NR:IBO-01/034

**SUBJECT: SUBMITTAL OF RECOMMENDED COURSE OF ACTION FOR S1W LEACHING BEDS  
CAPACITY**

## S1W Leaching Beds Capacity Issues

Figure 1 Recommended Placement of SSCs

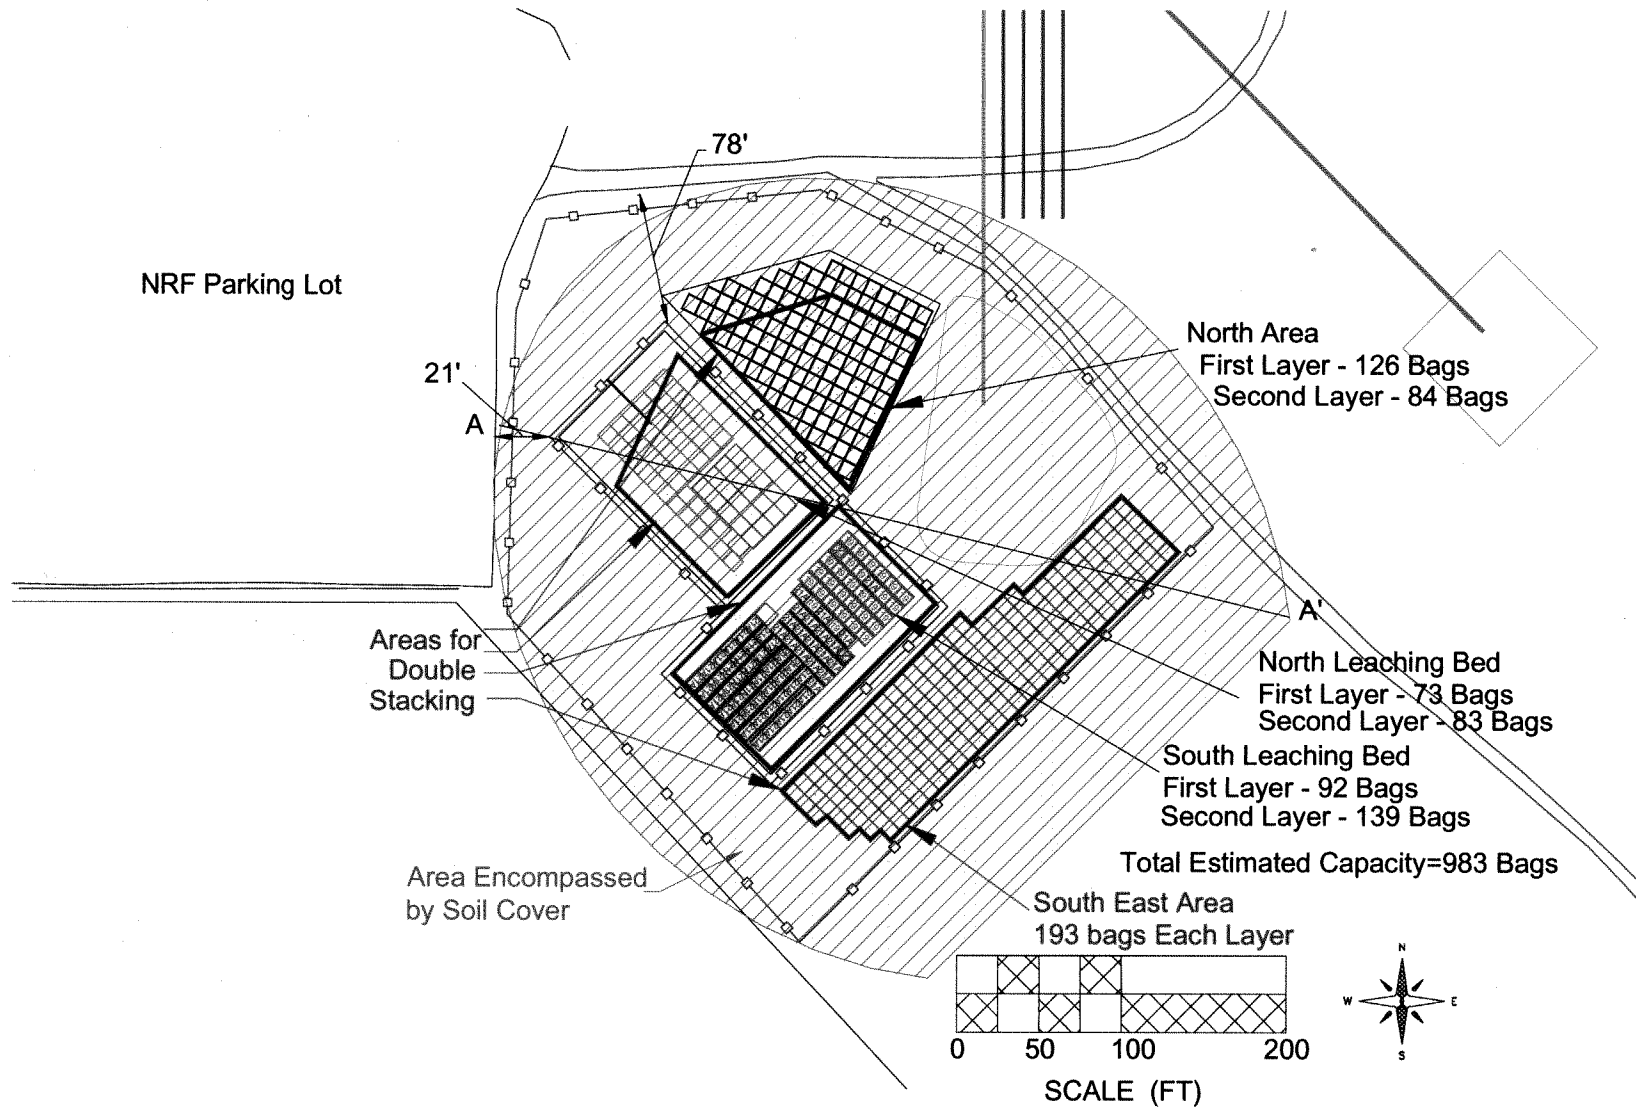
Because of the anticipated additional number of SSCs, the actions required to handle the additional SSCs must be addressed. The recommended action, shown on Figure 1, includes placing SSCs outside the leaching beds, but within the existing contamination zone. The area outside the beds would need to be grubbed (vegetation removed) and prepared for the SSCs. In addition, a foot or two of surface soil could be removed in the locations outside the beds where the SSCs are to be placed. This soil could be placed around the SSCs in the leaching beds where void spaces currently exist. The removal of this soil would serve several purposes, as follows:

A double layer of SSCs would be placed within and adjacent to the leaching beds. The double layer of SSCs would be placed in strategic locations within the S1W Leaching Beds. Since the leaching beds have tapered sides, it is estimated that another row of SSCs can be placed around the perimeter when the second layer of SSCs is placed in the leaching beds. This would allow the second layer to have significantly more capacity in the leaching bed area than the first layer at the bottom of the beds. For example, in the south leaching bed the first layer contains 92 SSCs, but the second layer (including the additional row of SSCs around the perimeter) would potentially contain 139 SSCs. Portions of the north bed will contain only a single layer, to prevent encroachment of the engineered cover on the NRF parking lot and perimeter road.

The recommended action is shown in Figure 1 (with a cross-section view shown in Figure 2). This would have a minimal affect on the design of the proposed cover. SSCs on the second layer would be strategically placed such that the perimeter dirt road would not be impacted.

Figure 2 Cross-section from Figure 1

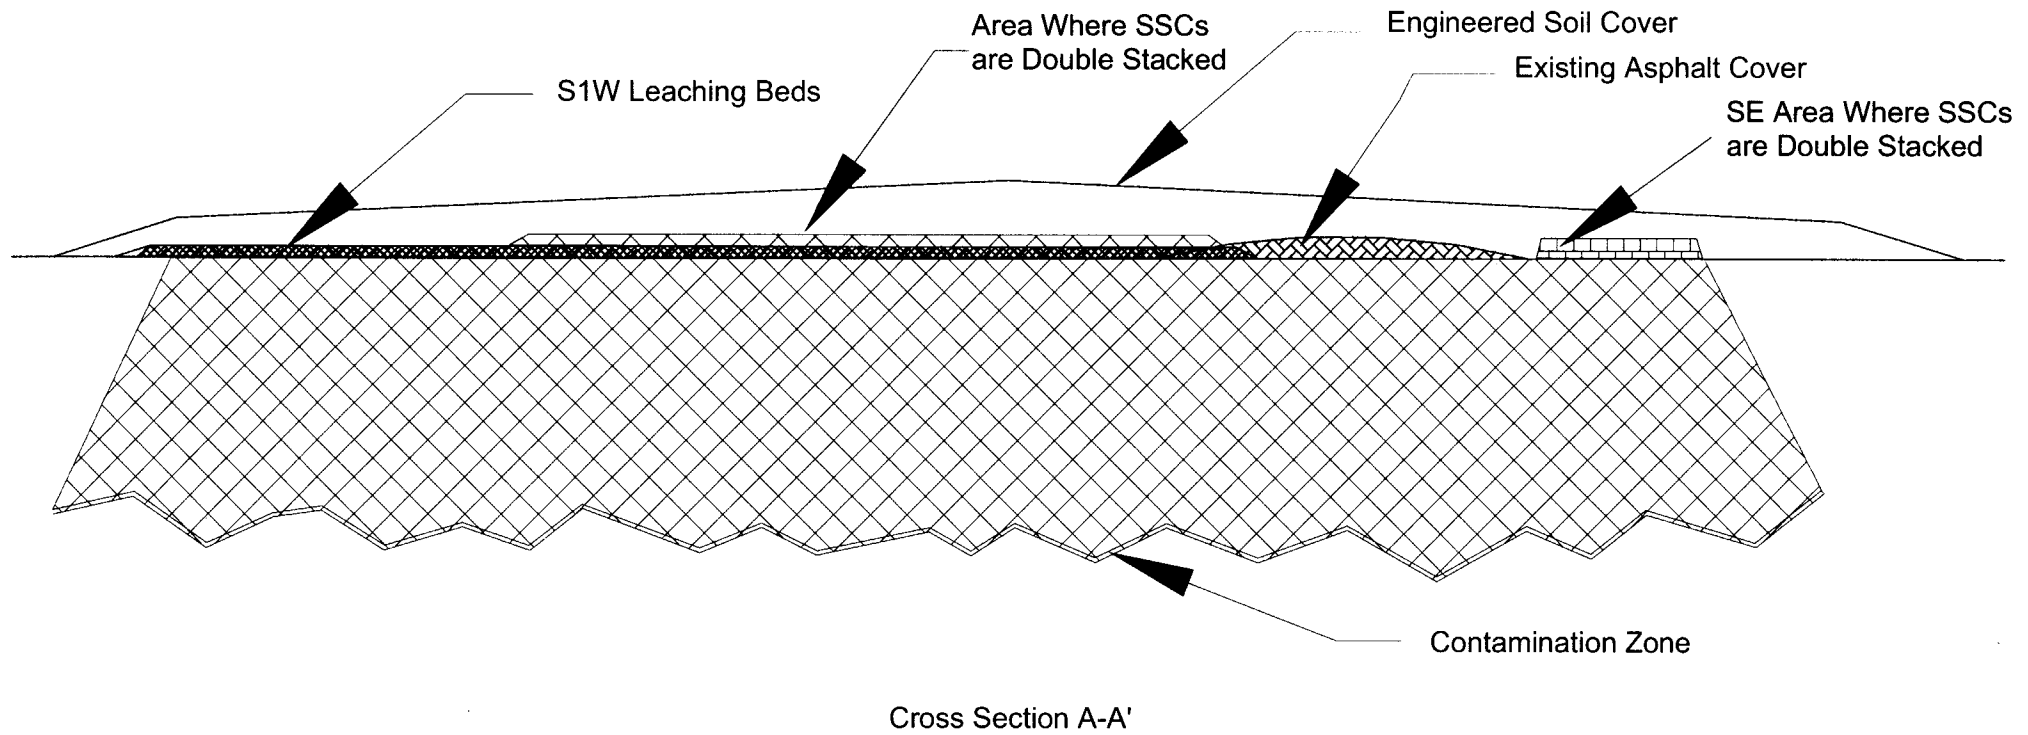
The Work Plan states that a 6-12 inch layer of soil would be placed between the two levels of SSCs. After discussions with the current subcontractor personnel who have experience with road construction and landfill operations, a soil layer of at least 18 inches is needed to provide the proper stability for heavy equipment to transport and place the SSCs for the second level. The reduced loading height of the SSCs will counteract the increased height due to this soil layer.

Figure 3 Original Proposal for SSC Placement given in the Phase I RD/RA Work Plan

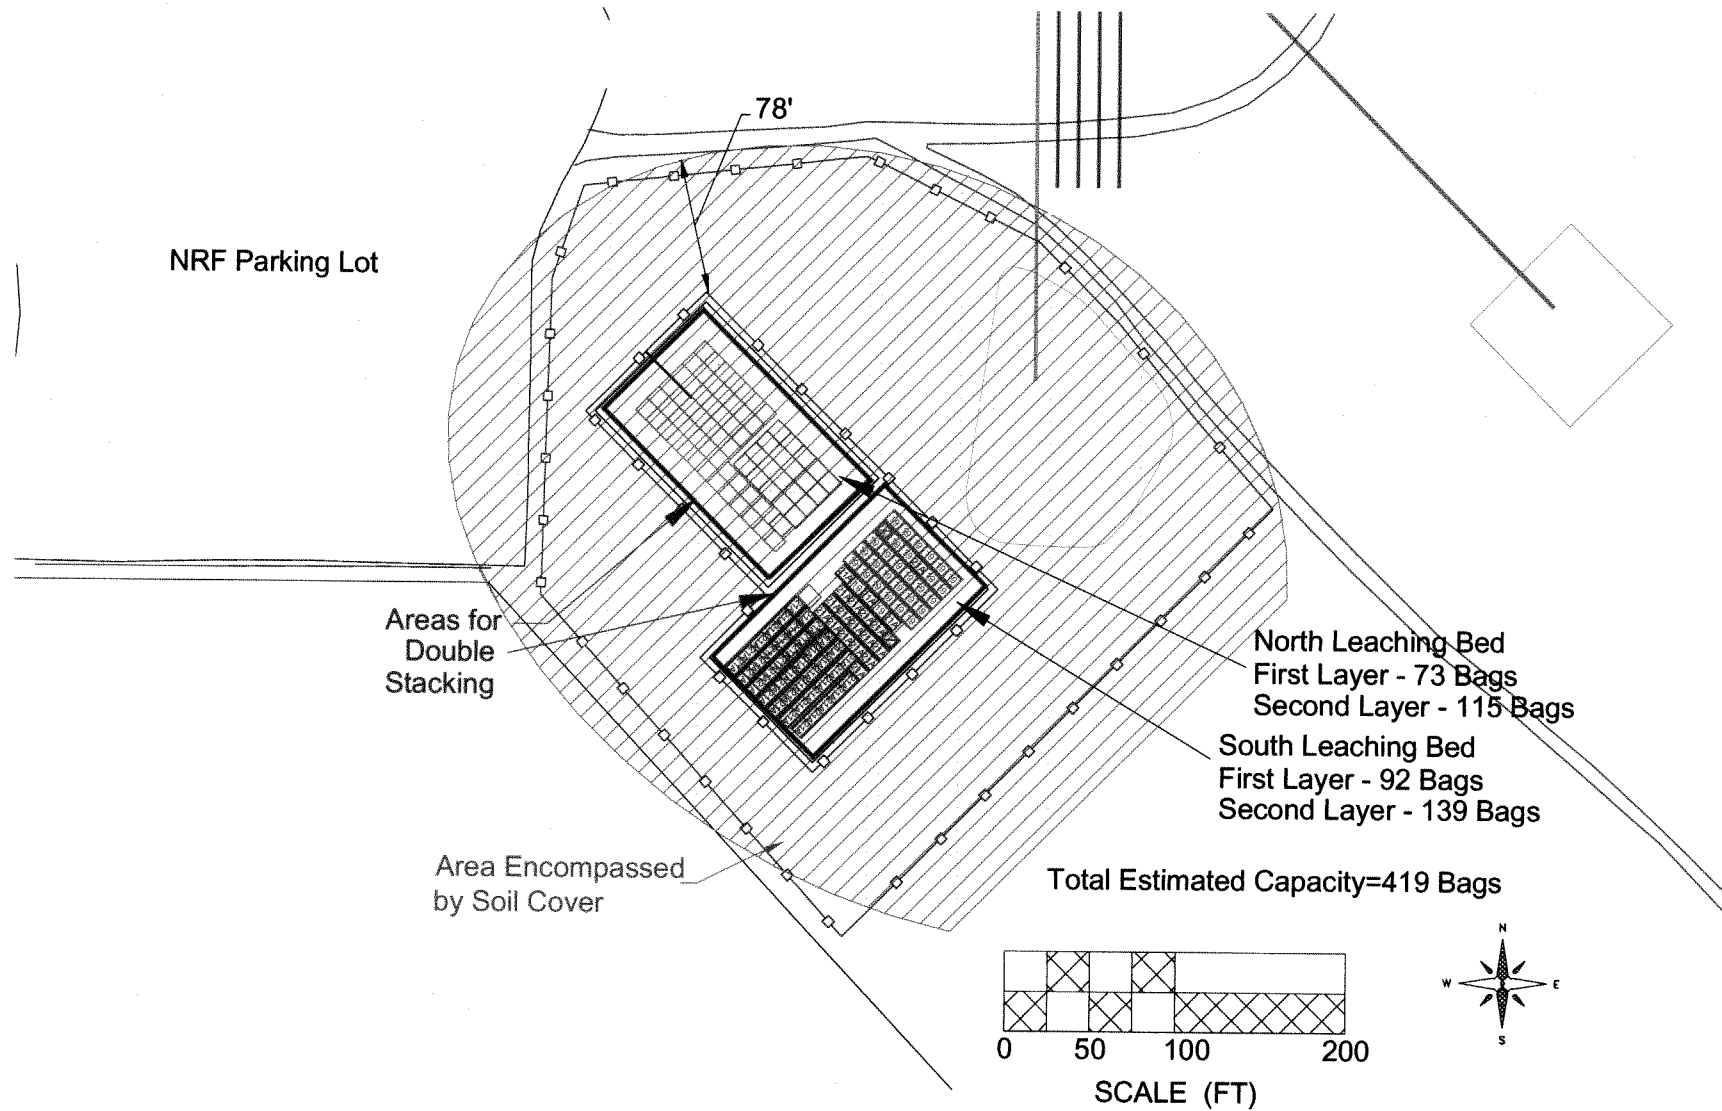
The option given in the Phase I RD/RA Work Plan showed a double layer only within the leaching beds. As can be seen from Figure 3, the original proposal identified in the Work Plan, the currently estimated soil from the remaining CERCLA remedial actions could not be accommodated within the original capacity. Absent an amended on-site soil plan, excess soil would have to be sent off-site for disposal at a proposed soil repository at the Idaho Nuclear Technology and Engineering Center (INTEC), the Radioactive Waste Management Complex (RWMC), or an off-INEEL facility such as Envirocare in Utah. In addition, shipment of SSCs off-site would require more sampling of the soil (for characterization purposes), would tend to retard the excavation work, and would incur additional costs for sampling, packaging, transportation, and disposal. The Feasibility Study estimated off-site disposal of soil at \$400 per cubic yard. Figure 3 shows that an estimated total of 419 SSCs could be placed in double layers within the leaching beds. This would require up to 472 SSCs (3500 cubic yards; \$1.4M) to be sent off-site if the higher soil volume estimates from Table 1 are encountered.
